CLOCKTOWER SQUARE RETAIL CENTER
CLOCKTOWER SQUARE RETAIL ASSOCIATES
SCALE: 1" = 50'-0"

RETAIL
CLOCKTOWER SQUARE CENTER
SHEET 2 OF 2
86-6001

TENANT FINISH IMPROVEMENT
541 N. SABLE BLVD.
AURORA, COLORADO 80011

NEW TRASH ENCLOSURE

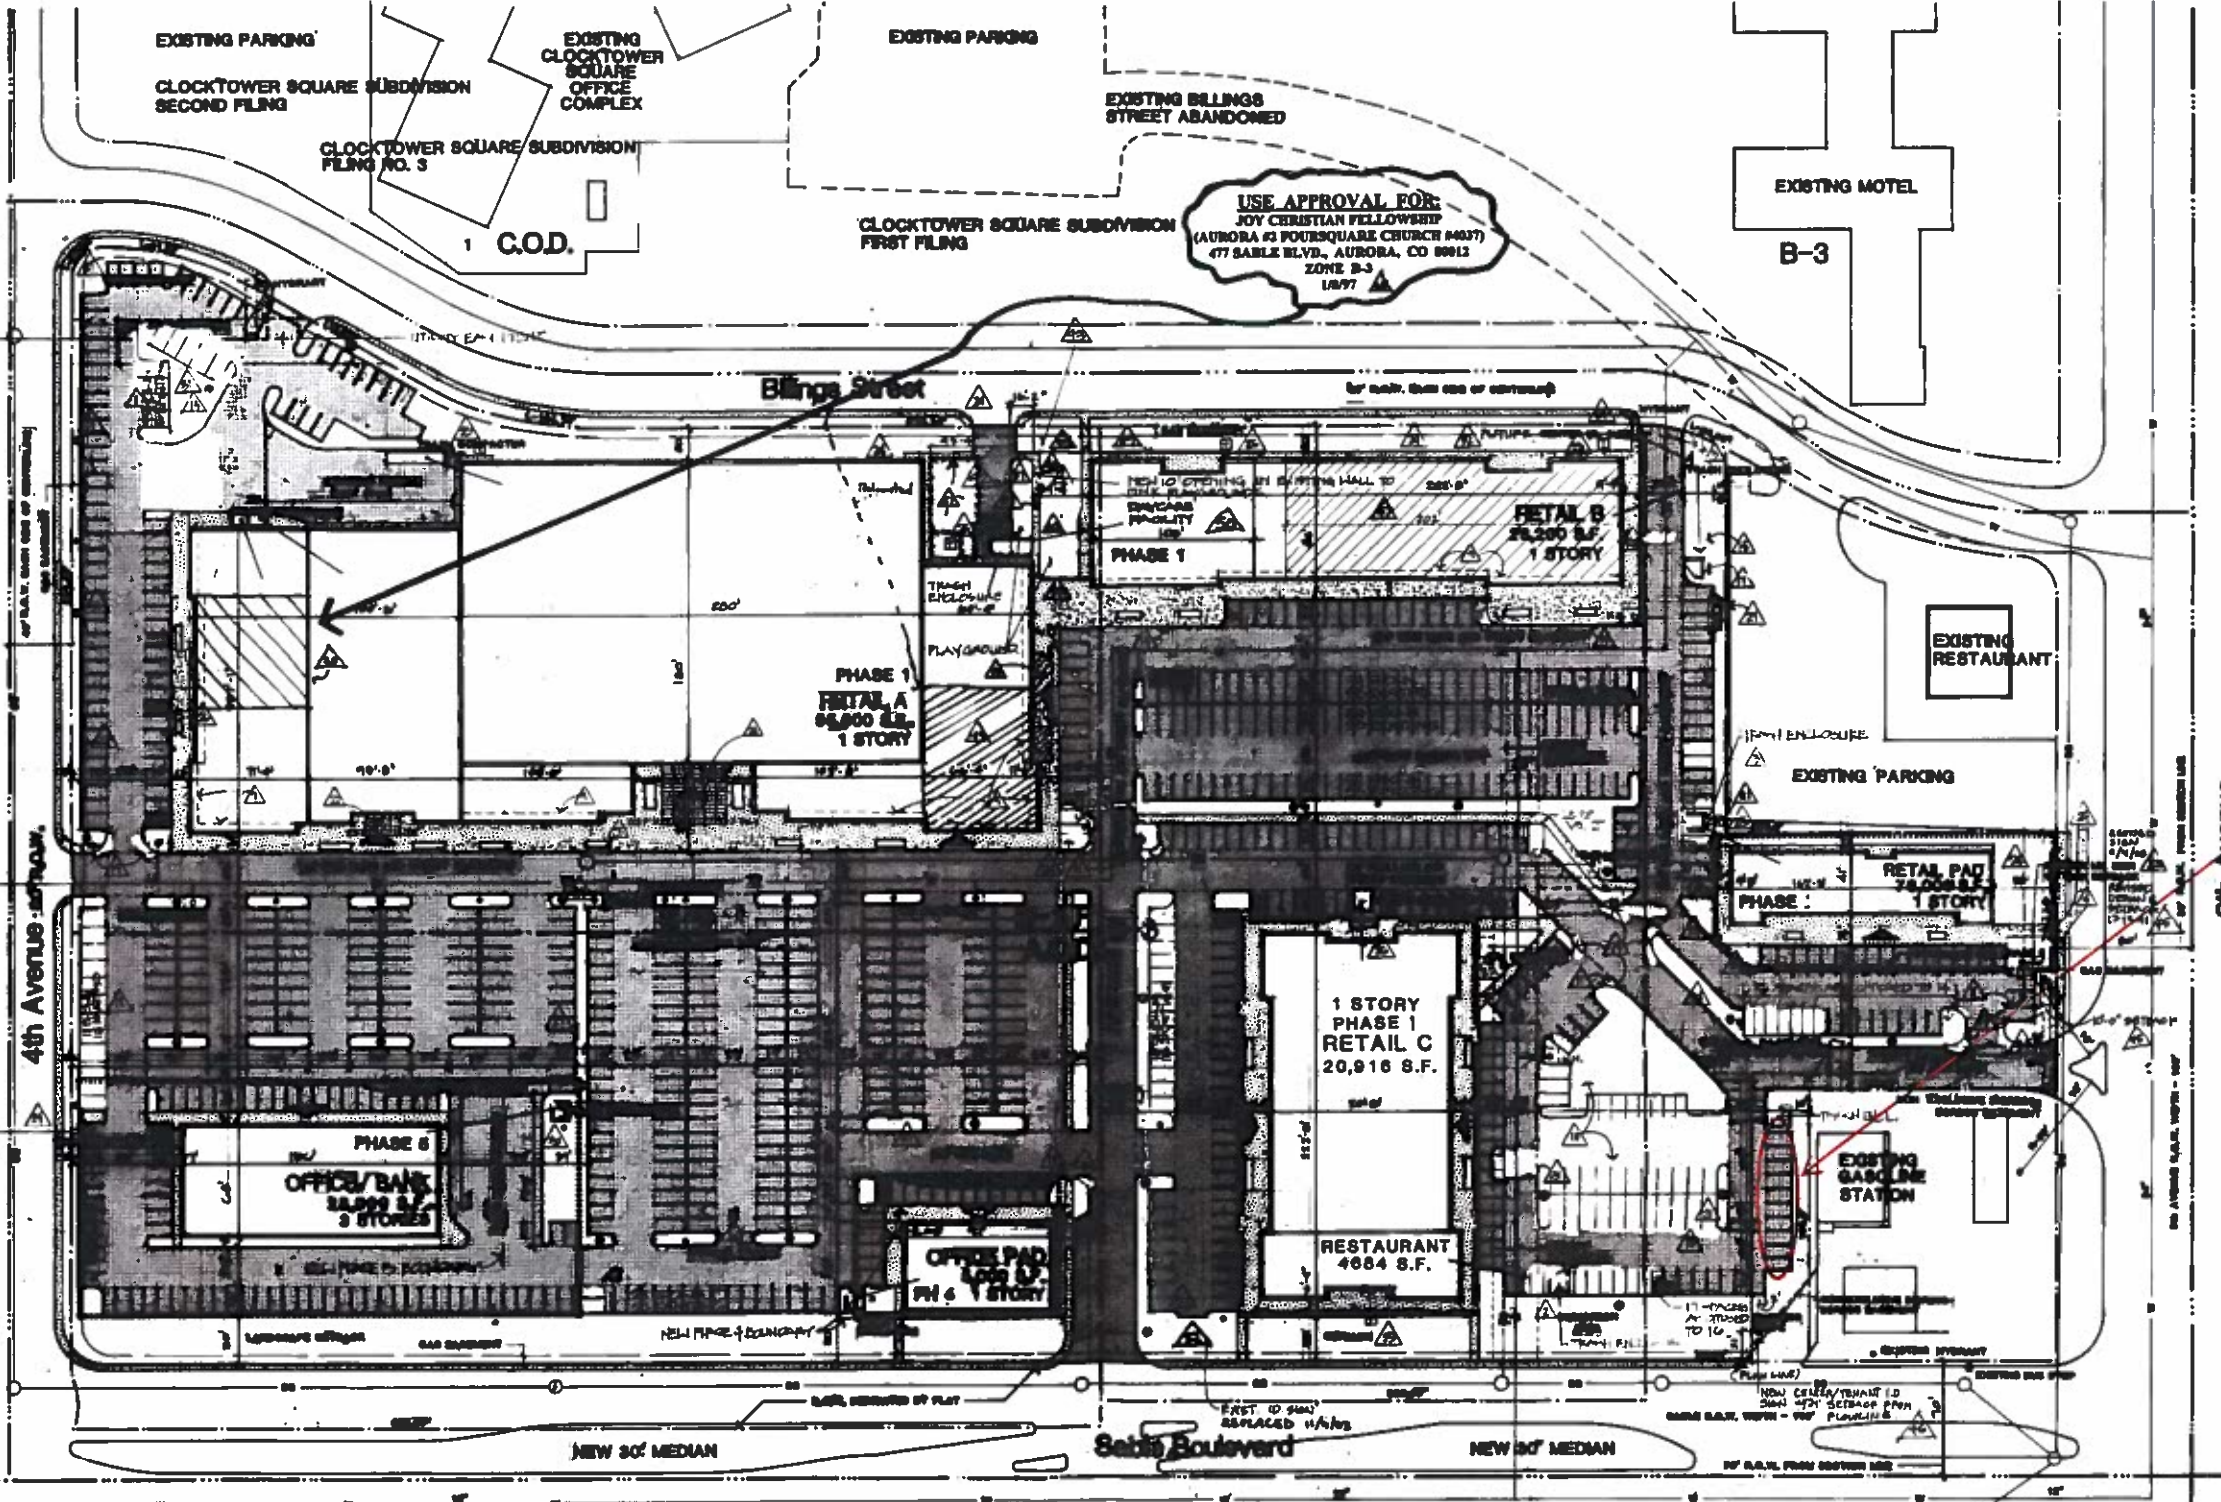
ADM. AMDT. 6-11-86
PARKING LOT LAYOUT IN SW CORNER
IS CHANGED TO FACILITATE SITE
USE. IN E AND ALLOW MORE
ROOM FOR TRUCK DELIVERIES
TO THE LOADING DOCK.

THE EXISTING 6' HIGH OF THE
CLOCKTOWER SQUARE SUBDIVISION
IS MOVED TO THE NEW LOT LINE
OF THE NEW TRUCK DELIVERY
AREA.

ADM. AMDT. 5-21-87
DASHED LINE INDICATES RECESSED
GRADE FRONT TO CREATE 6' X
WIDE COVERED WALKWAY. BUILDING
AREA IS REDUCED BY 444.6 SF
IN BUILDING 1 AND 2.33 G.F. IN
BUILDING 15.

THE PHASE 3 RESTAURANT AND IS
DELETED AND THE PLAN FOR THIS
AREA IS REVISED.

DELETE (1) ONE PARKING SPACE.
CHANGE COMPACT SPACES TO STANDARD
SPACES - DELETE (5) THREE SPACES
TOTAL.

DELETE (8) EIGHT PARKING SPACES.
DELETE (20) TWENTY SPACES.
DELETE (6) SIX SPACES.

DELETE TRASH ENCLOSURE (NO LONGER
REQUIRED DUE TO DESTRUCTION OF PLOT).
HAVE TRASH ENCLOSURE TO PROVIDE
MORE LANDSCAPES.

ADD (15) FIFTEEN PARKING SPACES.
EXPANDED CURB RADIUS FOR IMPROVED
TRAFFIC CIRCULATION.

ADM. AMDT. 7-29-87
ADD FREESTANDING ENTRANCE
WITH OPEN TRELLIS ROOF.

ADM. AMDT. 11-18-87
REPLACE 6' HIGH JOINT ID SIGN WITH 14'
HIGH MONUMENT SIGN DESIGNATED LIKE A
TOWER. 14' MONUMENT SIGN.
SIGN TO BE LOCATED 19' FROM 6' HIGH
PROPERTY LINE + 11' FROM SABLE BLVD.
PROPERTY LINE. GRASSY AREA LOCATED
OUTSIDE OF SITE BOUNDARY. TRAILER
SIGN BARS TO BE COMPLETED WITH METAL
FENCES. PHASE 1. THE SIGN COLOR IS TO
BLDG WITH A TOWERED SIGN. MATCHES BLDG
EXTERNAL SIGN LETTERS OF 11-18-87.

ONE OF THE JOINT ID SIGN, CA SABLE BLVD
IS RELOCATED TO THE OTHER SIDE OF THE
COURT YARD.

CHANGE TREE VARIETIES ON THE LANDSCAPE
PLAN.

ADM. AMDT. 10-9-87
Add and/or delete sidewalks as shown.
Transmute and location.
Have, add and/or delete plantings as shown.
Stump over inlet location.
Not used.

Add 8" to 24" high railroad tie retaining wall.
Trash enclosure to be built during phase 3 construction.
Have, add or delete light poles as shown.

ADM. AMDT. 9-7-83
REMOVE EXISTING SIDEWALK IN PLAYGROUND
AREA AS SHOWN.
REPLACE EXISTING SIDEWALK WITH NEW GRASS
SPACE AT PLAYGROUND AREA. - SEE L-1
A 1" X 6" WIDE FERTILIZED WALK - CONCRETE.
AC. 6" HIGH MASONRY WALL - ADJACENT TO MATCH
EXISTING BUILDING FACE. - SEE DETAILS IN FILE.
ADD 6" HIGH WOODSCREEN FENCE AND GATES - SEE DETAILS IN FILE.
STAIRS TO MATCH EXISTING BUILDING COLOR.
AC. PLAYGROUND BOUNDARY AS SHOWN.

RELOCATE EXISTING TREE - SEE LANDSCAPE
PLAN SHEET L-1.

APPL. AMT. 9-3-97
ADD 6 FT HIGH WOOD SCREEN FENCE, LEAVE 6 FT WIDE
OPENINGS BETWEEN FENCE AND BARS.
REPLACE TRASH SHED CENTER 10'

ADMIN. AMDT. 10-11-90
EXPANDED PLAYGROUND PLAY AREA BY ADDING NEW
6' HIGH WOOD FENCE 1/2" STUCCO TYPE FINISH
ADD ONE 6' X 6' H. IRONSTONE PINE OUTSIDE
PLAYGROUND FENCE.

ADMIN. AMDT. 12-13-91
CHANGE DESIGN OF CENTER 10 SIGN (SEE SHEET 1)
REDUCE SETBACK OF NEW SIGN ON 6TH AVE FROM 14' TO 10'
RELOCATE A NEW CENTER 10 SIGN ON SABLE BLVD
AND INCREASE SETBACK TO 21' FROM PLANK LINE.

1 TRASH ENCLOSURE LOCATION
N.T.S.

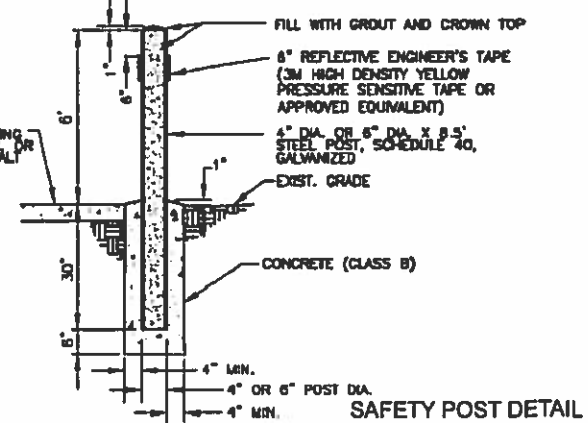
NEW TRASH
ENCLOSURE
LOCATION FOR
541 N. SABLE
